ADDENDUM 5

DATE: June 16, 2016

PROJECT NAME: NAVAJO TRIBAL UTILITY AUTHORITY WASTEWATER TREATMENT PLANT UPGRADES

PROJECT NO. 115111

NOT TO SCALE

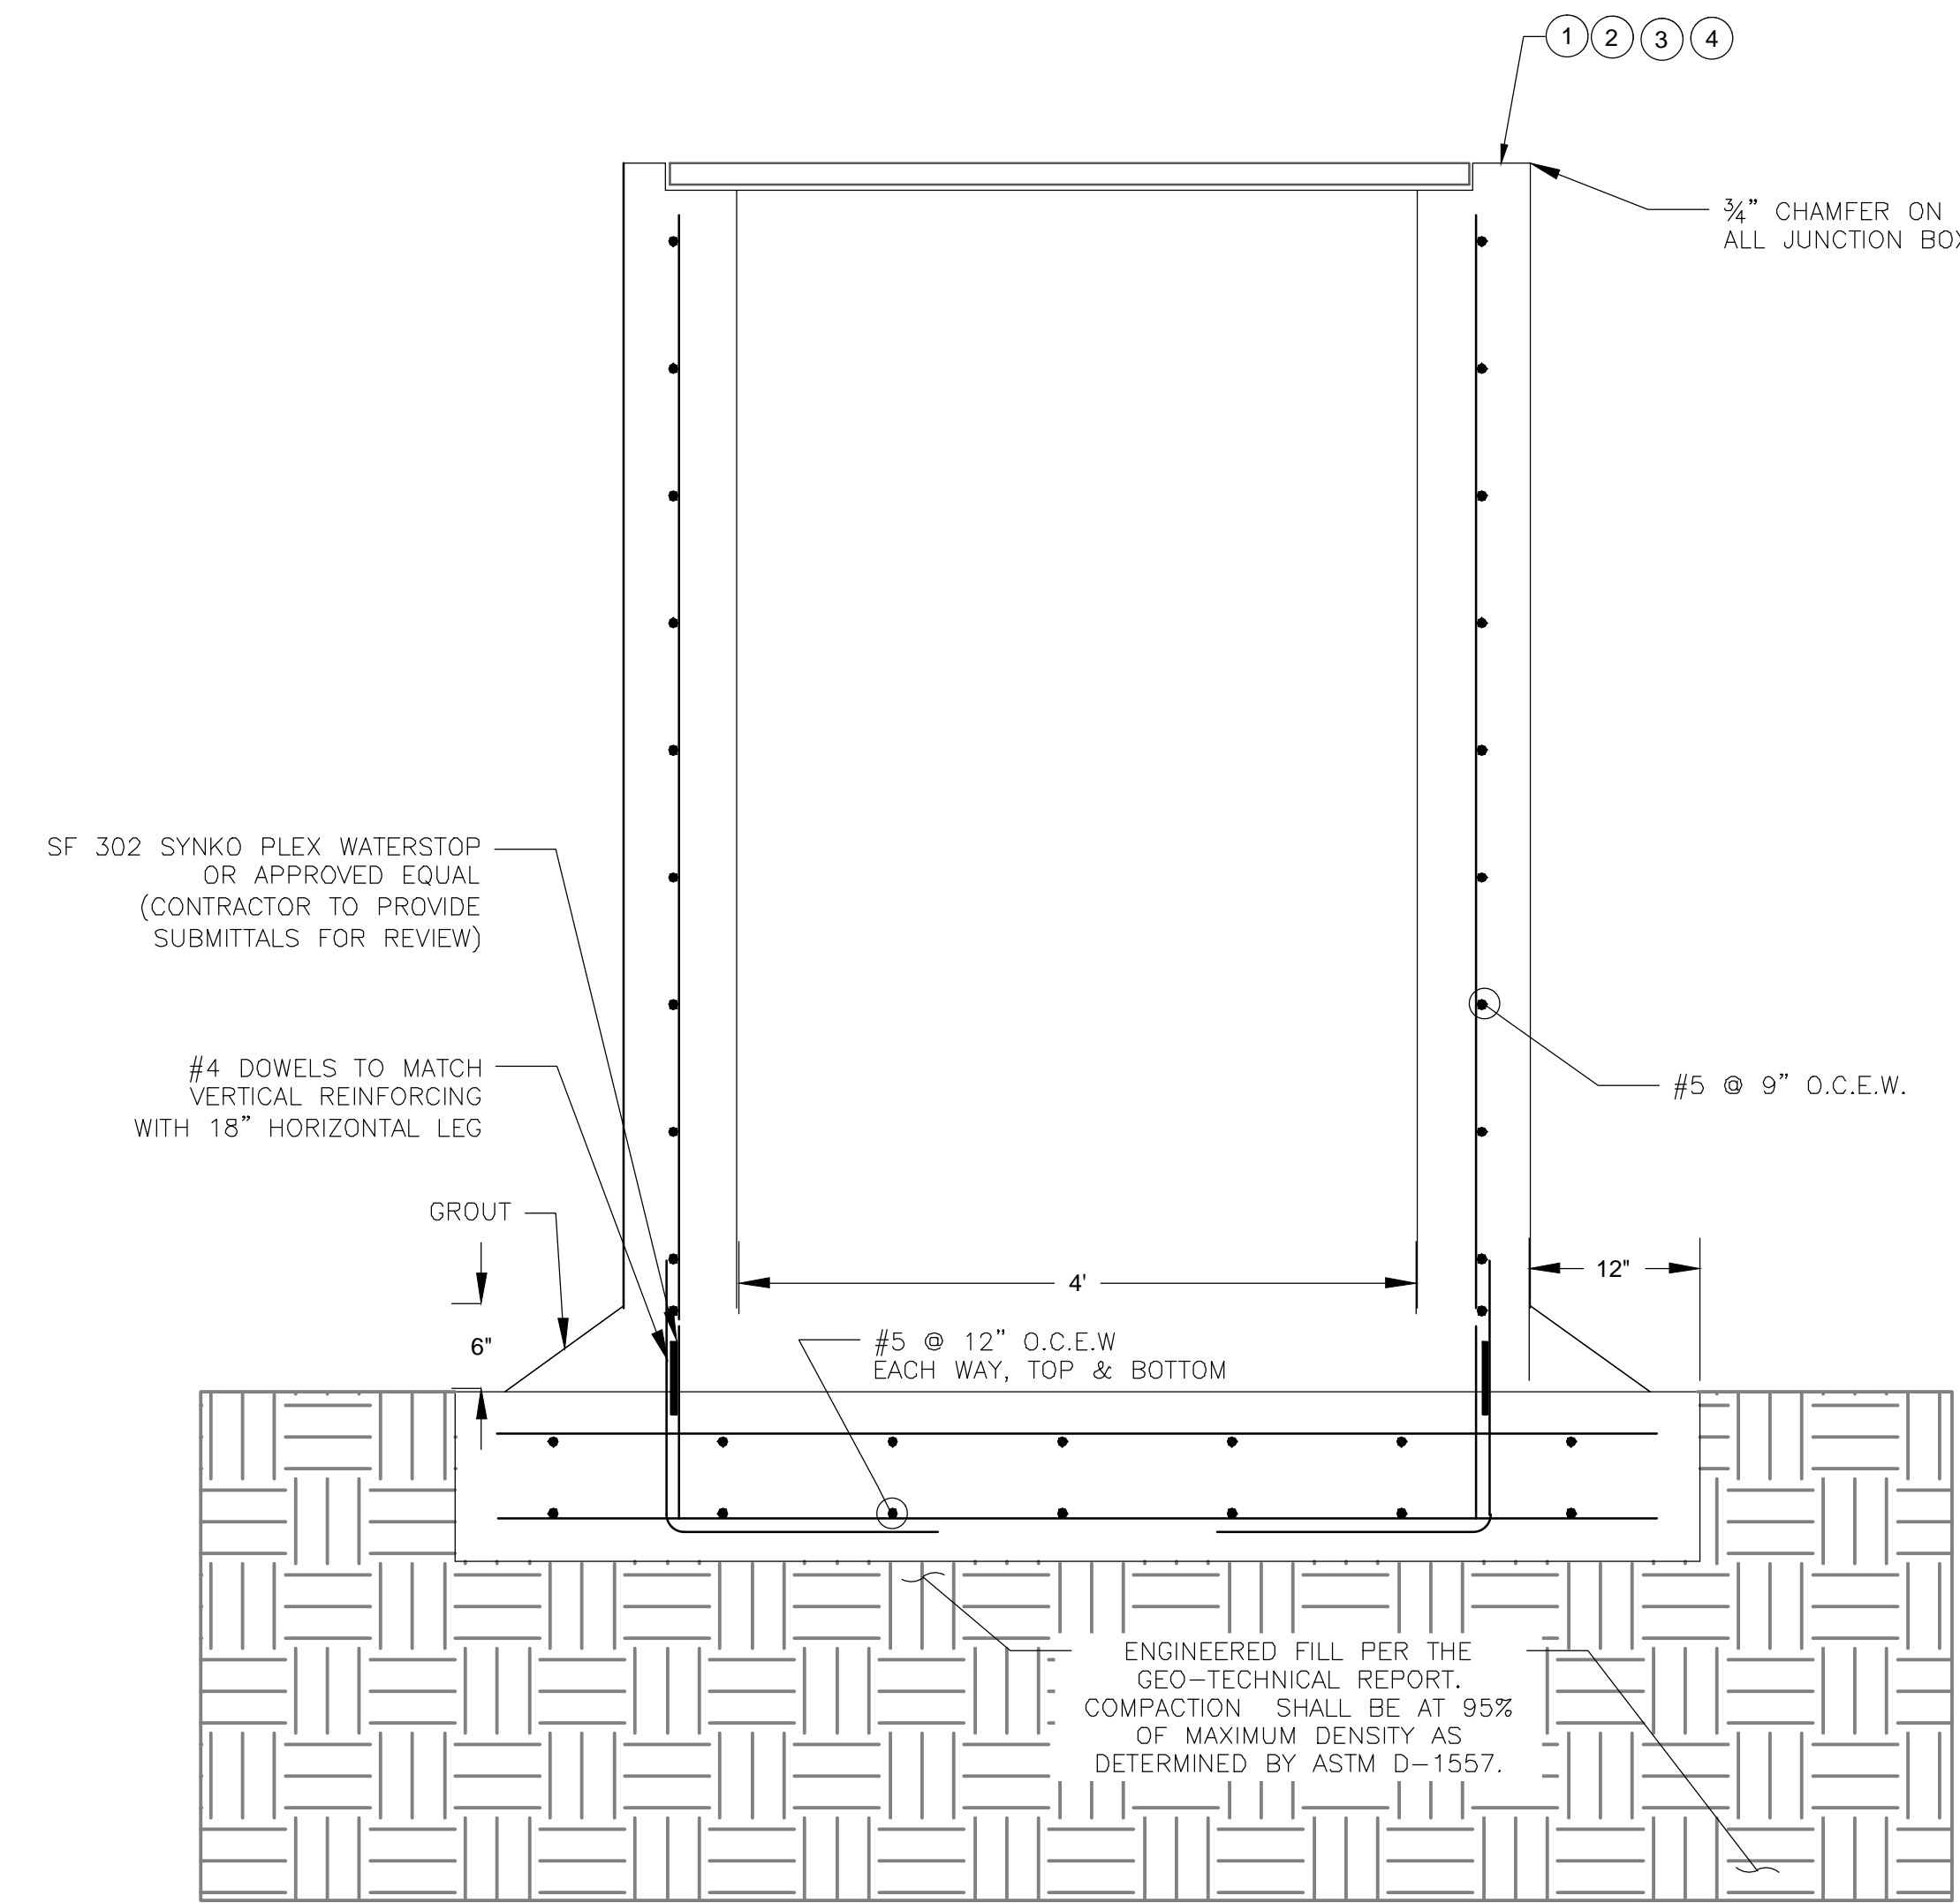
6. **Question:** Regarding Supplemental Specifications section 31 55 00 – Earth Retention, where does this apply? The only structure that we see that may need something is the new junction box at Chinle between dells 2 and 4. If cell 4 has water in it that will be a problem to dig that deep (20' below existing ground). Soil nails don't look like the right application for this

1. **VOLUME 2.1 CHINLE WWTP:** REMOVE sheet 16 and 17 dated April 2016 and REPLACE with the attached sheet 16 and 17 dated June 2016.

- 1 STRUCTURAL CONCRETE: FURNISH AND INSTALL REINFORCED PORTLAND CEMENT CONCRETE PER STRUCTURAL SHEETS, COMPLETE AND IN PLACE.
- 2 SUBGRADE PREP: PREPARE SUBGRADE FOR STRUCTURES INCLUDES EXCAVATION (3FT BELOW BOTTOM FOUNDATION ELEV.) AND COMPACT PER STS 31 20 00, COMPLETE.
- 3 STRUCTURAL FILL: FILL CONSTRUCTION FOR STRUCTURES INCLUDING PLACEMENT AND COMPACTION OF SUITABLE ENGINEERED FILL MATERIAL (STS 31 20 00) AND REINFORCING GEOGRID (STS 31 05 19) , COMPLETE.
- 4 EXCAVATE AND SPOIL UNSUITABLE MATERIAL PER STD SPEC 206, COMPLETE.
- 5 FURNISH AND INSTALL SLUICE GATE PER SUPPLEMENTAL SPECIFICATION 35 20 16, COMPLETE AND IN PLACE.
- 6 FURNISH AND INSTALL GRATE PER SUPPLEMENTAL SPECIFICATION 05 53 13 , COMPLETE AND IN PLACE.
- 7 FURNISH AND INSTALL 24-INCH SDR SAS PIPING INCLUDING FITTINGS, TRENCHING, COMPACTION, COMPLETE AND IN PLACE.

Response: Please see the modifications to the bid documents below. These modifications should eliminate the need for earthwork retention for junction box 7.
